Staff Report Template – Site Plan Review for Commercial or Industrial Development

SITE PLAN
 LINN COUNTY ADMIN
 OFFICE EXPANSION
 2730 PACIFIC BLVD SE
 ALBANY, OR 97321

SITE PLAN REVIEW & TREE FELLING APPLICATIONS

Sheet **C103**

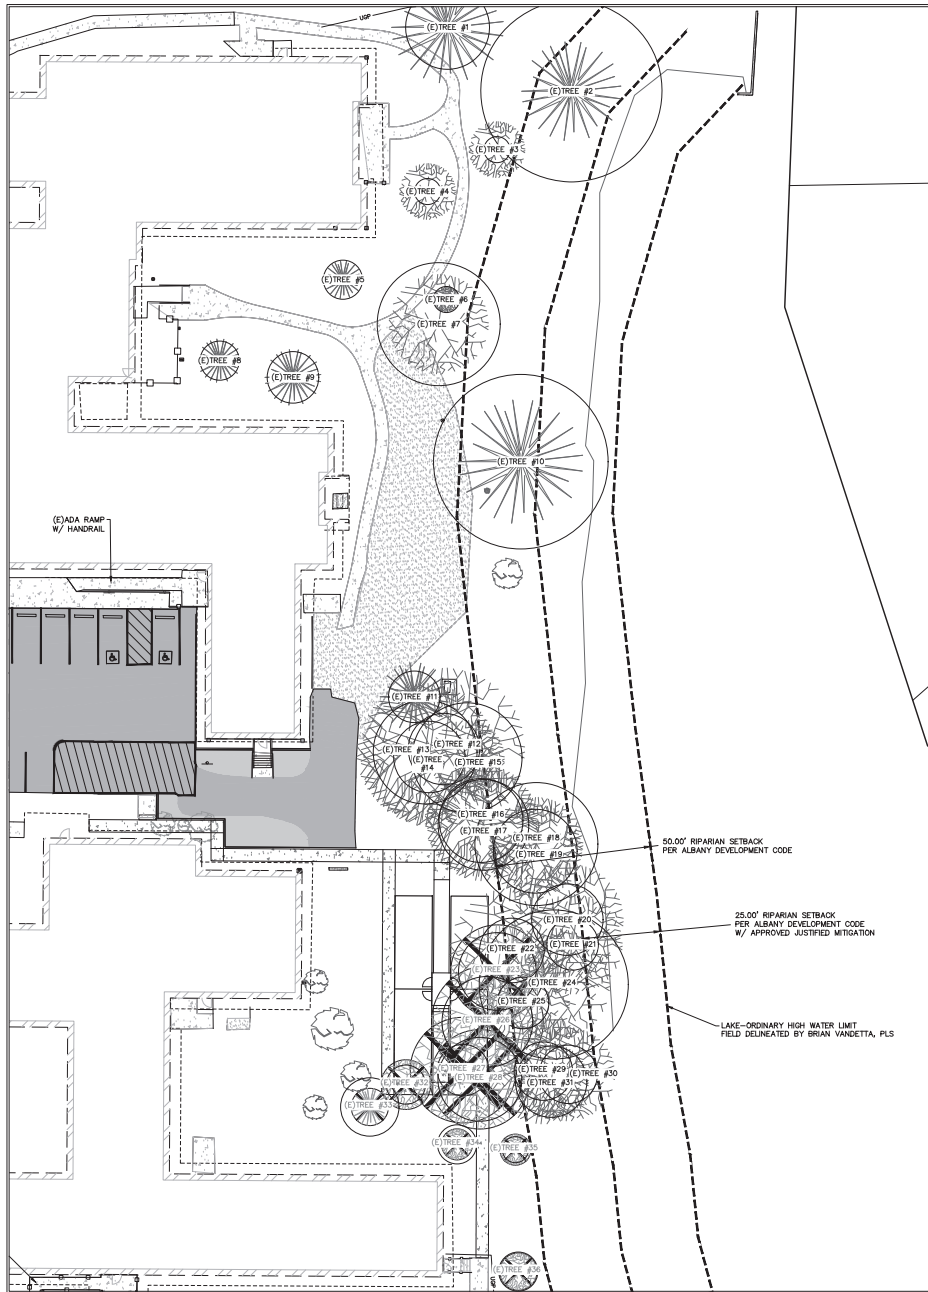
- 1) The plans are so small and very hard to read. Where exactly is the mobile office going to be located?
- 2) How long will the mobile office be in the particular location?
- 3) Will the mobile office match the exterior of the current structures on the property? (paint color etc)?
- 4) On the proposed site plan property quite a few large established trees have already been taken down which was very disturbing. Our lake is home to a vast variety of wildlife including, cranes, ducks, minks, fish, turtles, many birds, and most importantly bald eagles which nest in the area where the trees were taken down already. How many more trees are planned to be taken down and where?
- 5) What is the long term plan for this property? Does the city plan to build more building structures?
- 6) How long is the proposed construction going to last, including any future plans on the property?

The applicant proposes to fell a total of nine trees for the placement of two modular office units. The trees to be felled are not located within the Significant Wetland or the corresponding Riparian Corridor. Findings addressing tree felling are found within this staff report.

The proposed development is clustered near the existing development to limit the number of trees to be felled and to provide easy access to the existing development and improvements. The Albany Development Code does not contain design standards for matching materials or exterior colors for properties in commercial zoning districts located outside of a Village Center Comprehensive Plan designation.

The submitted comments were relayed to the applicant’s representative for further clarification concerning the development timeline and any further development plans upon the site. The applicant’s representative did not respond to comments submitted. Staff do not have any additional information to answer these questions.
